SITE PLAN

LEROY TOWNSHIP, LAKE COUNTY, OHIO

for: VAN WINKLE

CHK'D. H.J. DATE 12/13/01 DRAWING NO. 01-257

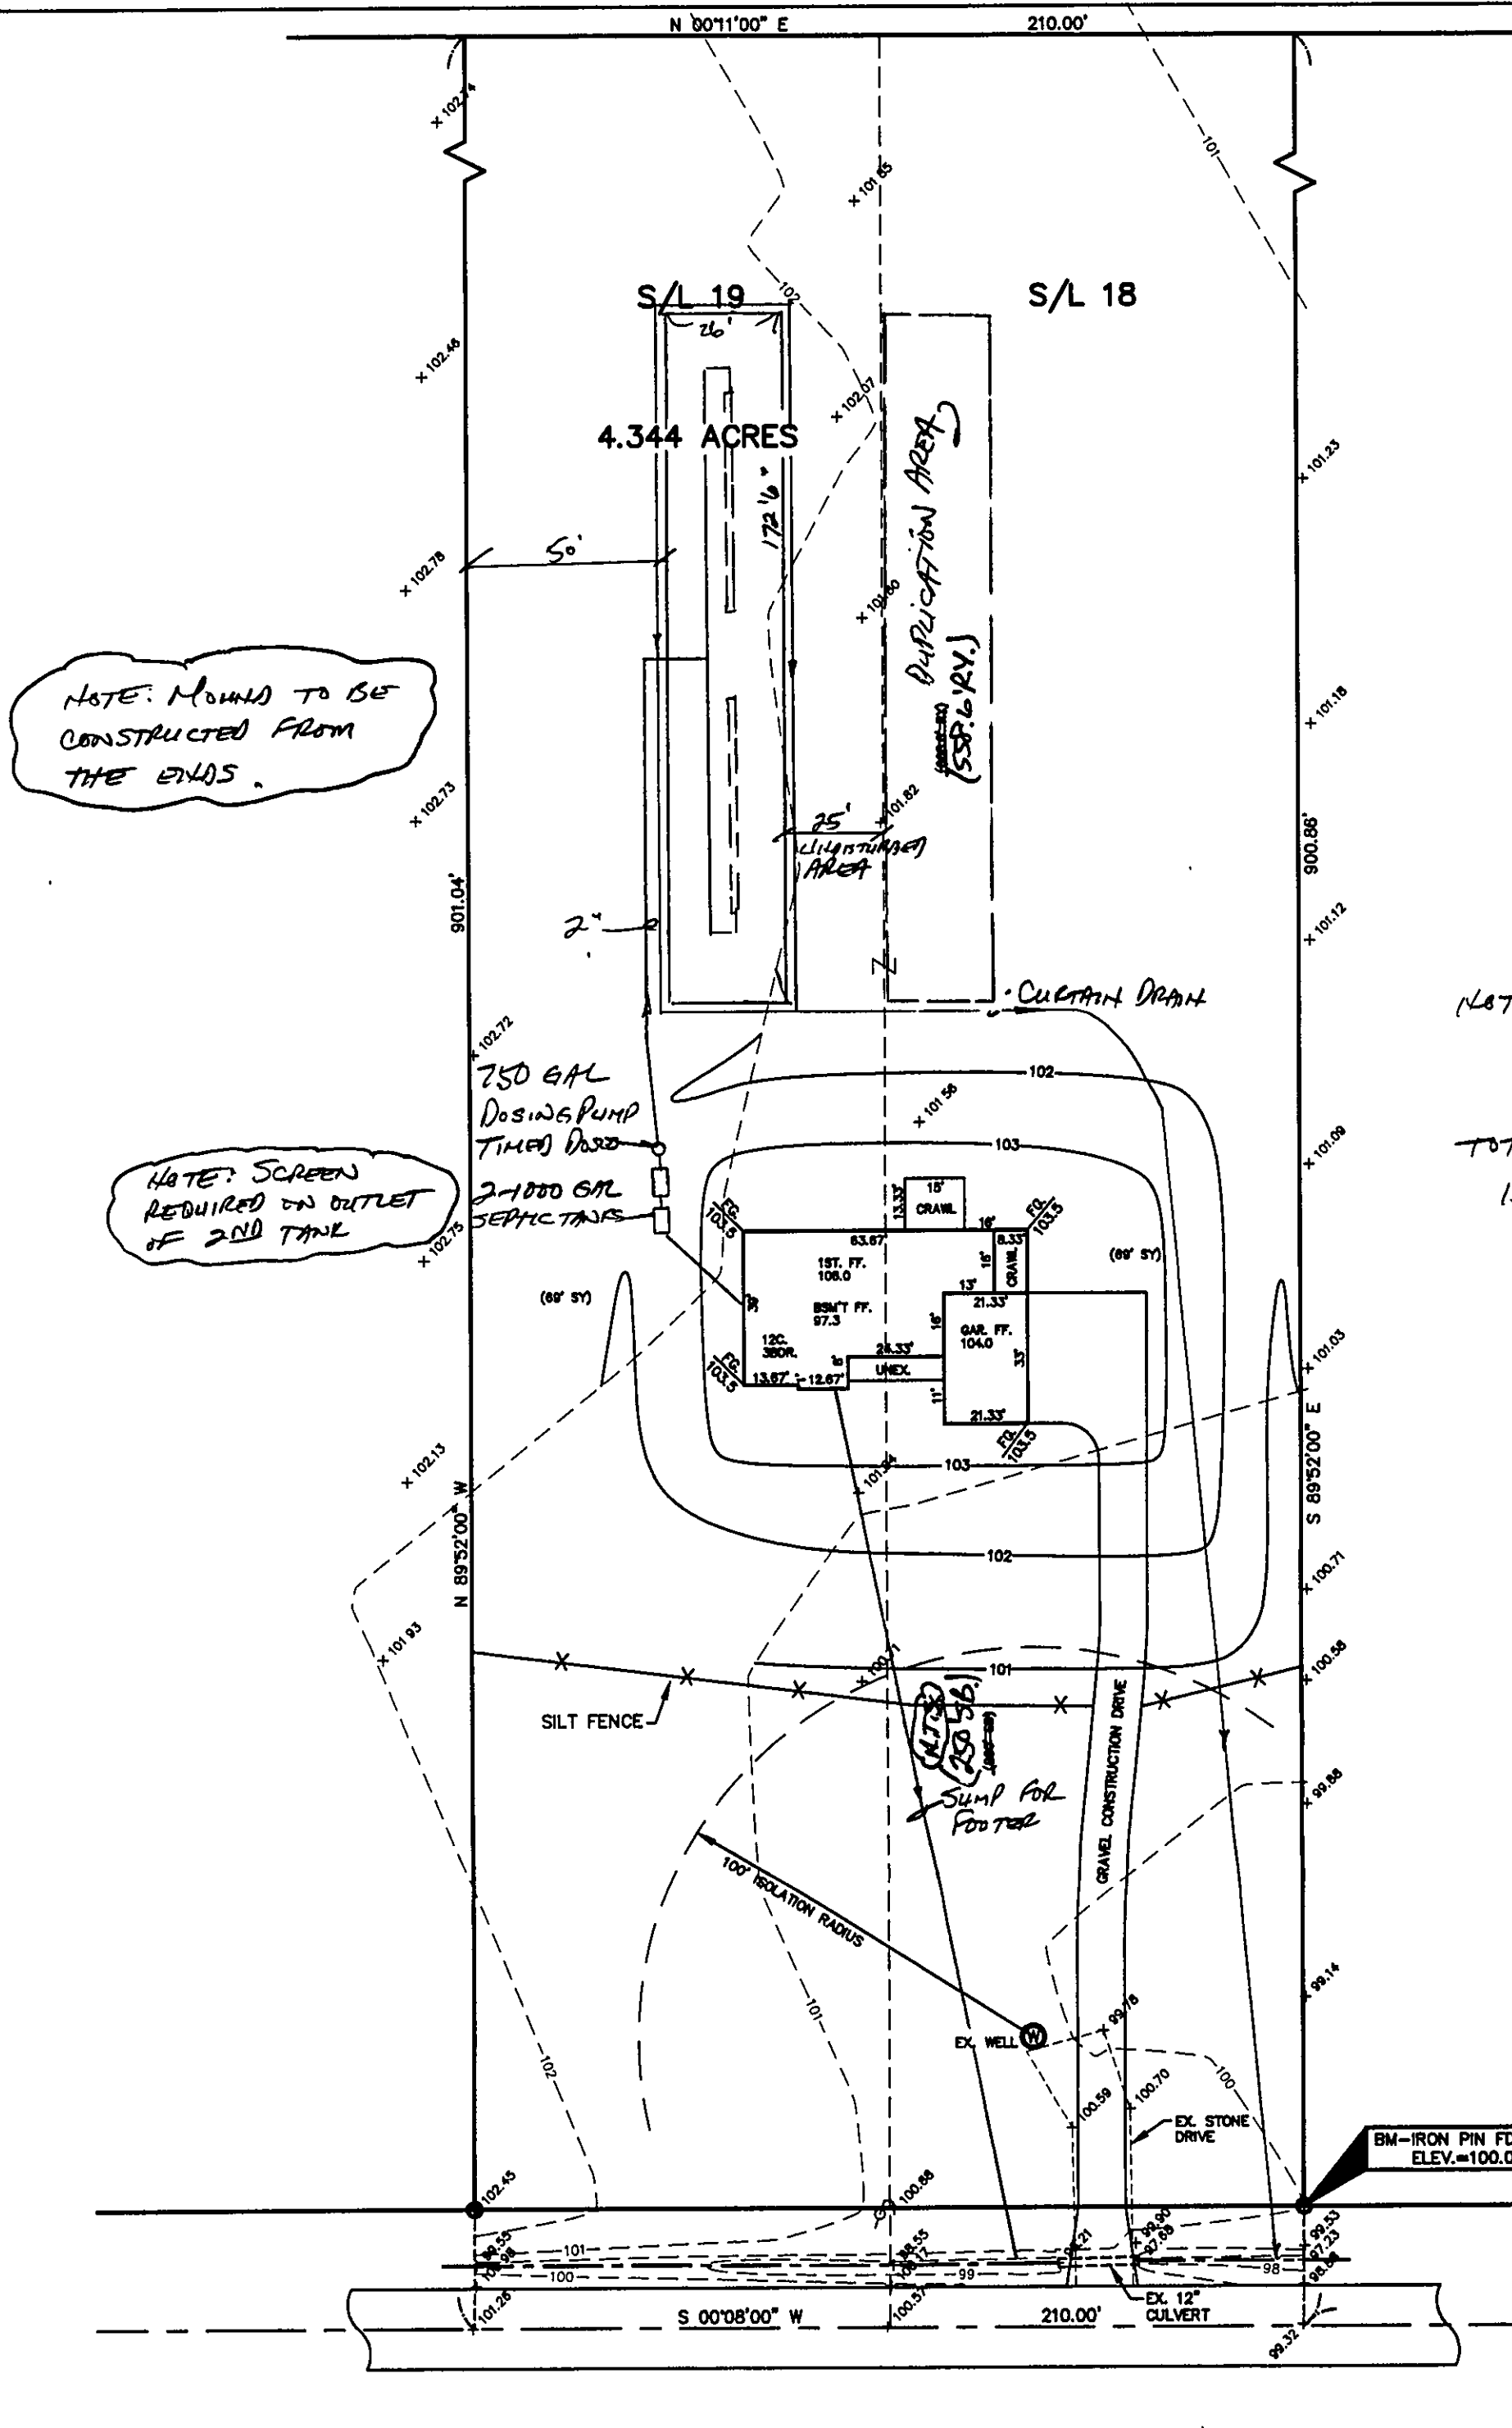
Grading Plan Approved as shown and/or noted  
JAMES R. GILLS, P.E.  
Lake County Engineer  
By GH Date 03/05/02  
15" min. Drive Culvert
